CHUGACH ELECTRIC ASSOCIATION, INC. Anchorage, Alaska

ADDENDUM #1

E2220061 – South Campus Pole Relocation – Phase 1

INTL TRANSMISSION SUBSTATION 59.8"AGH, ITIN 1-2 DUPLICATE DRAWING DISTRIBUTION PED61327159.8' AGH. ITIN 1-2. 138KY TRA DWG SIZE D CLASS CODE (1) 1 CLASS NO. (3) 450

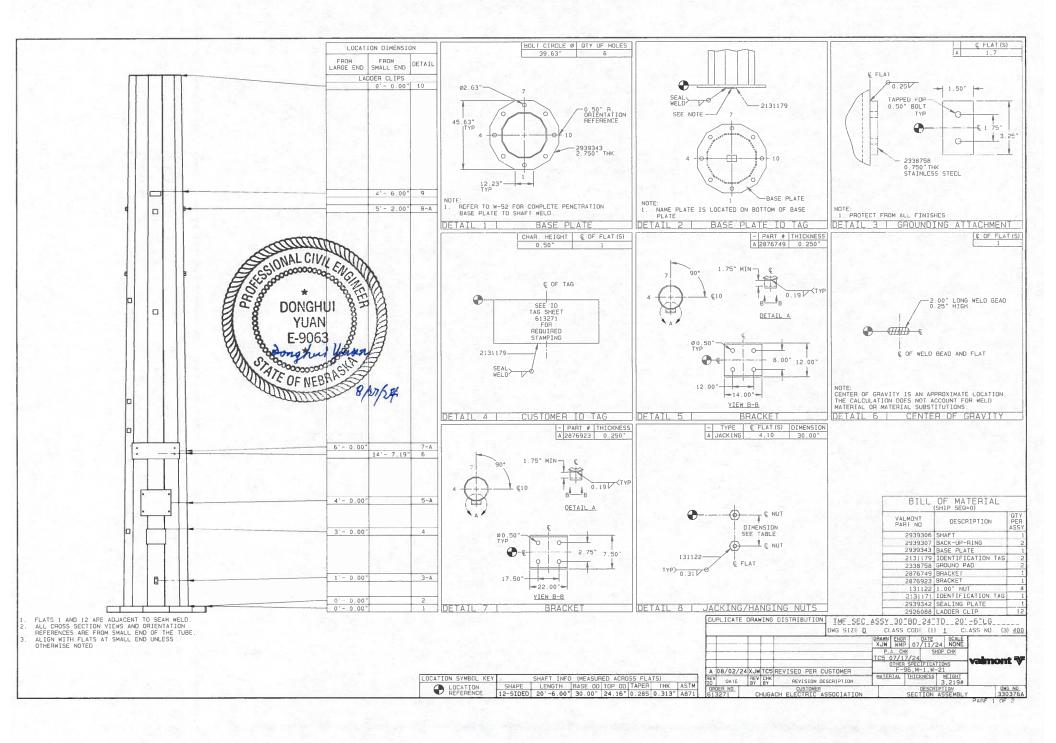
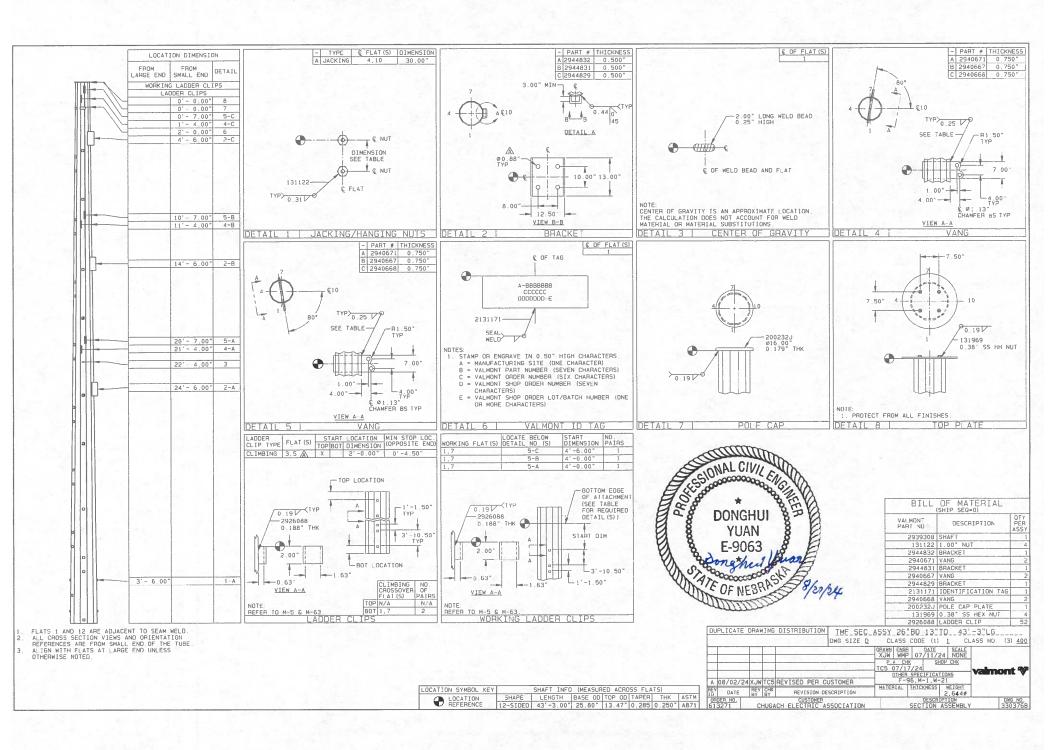
- Q14: How many pieces will each steel structure be in when Contractor picks up?
- A14: All steel structures have arrived and are stored in the BESS yard. See attached manufacturer's shop drawings for complete structure breakdown.

South Campus Underground Facilities

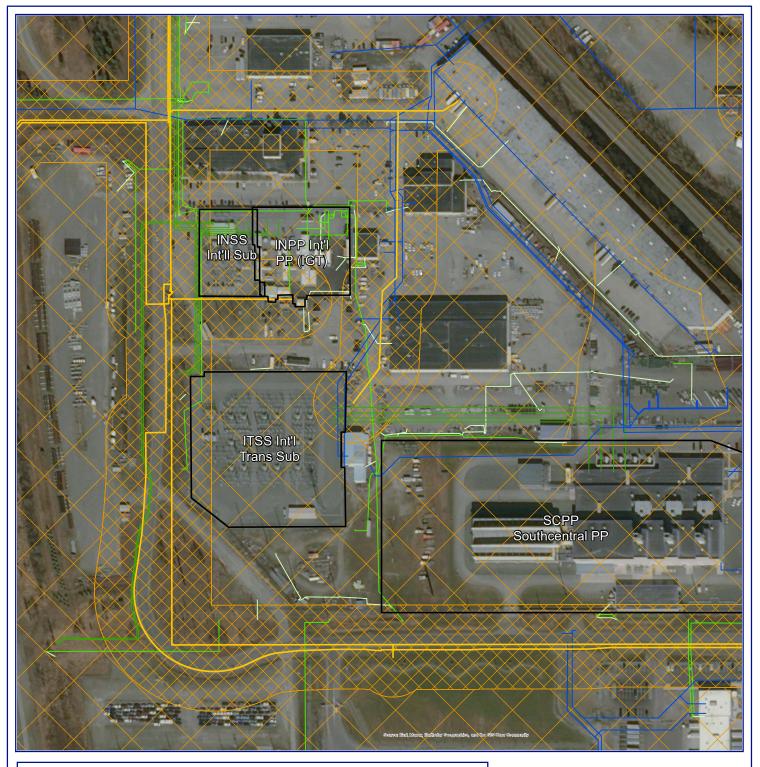
- Q2: Does CEA know of any underground impacts at the entrance where the new h-structure goes?
- A2: There is a storm drain running from outer West gate to the ditch West of Electron drive. Also, an Enstar high pressure gas line is in the ROW East of Electron drive. See attached South Campus Underground Facilities map and storm drain asbuilt. The contractor is ultimately responsible for obtaining locates and navigating around any underground utilities that may exist.

- Q18: New 35kv structure appears to be within 10ft of Enstars system. Please confirm new structure is more than 10ft away from Enstar. If within 10ft of Enstars system, will they require any special monitoring during the pile install?

- A18: That is correct, Enstar gas line does appear to be within 10ft of the furthest 34.5kV West pile to be driven. Therefore, contractor will need to have this line located prior to the driving process begins. If the line is within 10ft of the new pile, an Enstar representative would need to be present during the pile driving. The project team has discussed it with Enstar representative. See attached South Campus Underground Facilities map. Any costs associated with coordinating with Enstar are incidental to the affected bid unit.
